Service Note		
Product	Description:	Service note no.
M5000	Mono input sence doesn't work	760 10 T055

Modification For High Temp Stability on SUM-PCB (M5201-3): IMPORTANT: When having DSP-1/REV-1, with s.no. lower than 630345 or DSP-2/REV-2 with s.no. lower than 610255 for repair or service please make this correction. This modification concern only the SUM-PCB (M5201-3). We recommend that whenever you come across a DSP-card without the mod. that you make it.

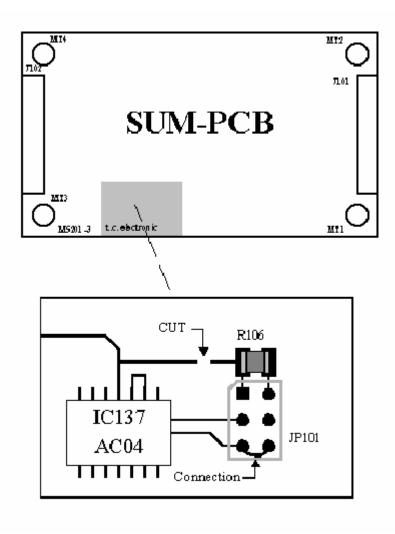
We have noticed that under special circumstances, due to a combination of high temperature and component spread it may be possible that an error occurs. The error is heard as randomly occurring noise clicks. This problem is due to timings' problems at the SUM-PCB. To cope with this problem in the easiest way for you (and us) we will ask you to do the following simple action to solve the problem.

Start separate the DSP-PCB (M5001-3) from the DIR-PCBs (Sandwich existing of M5201-3(SUM-PCB) and M5202-3(ADR-PCB)) by removing the 4 screws at the solderside of PCB M5001-3. Then when having separate these PCBs you have to make one track cut and one short as shown on figure.
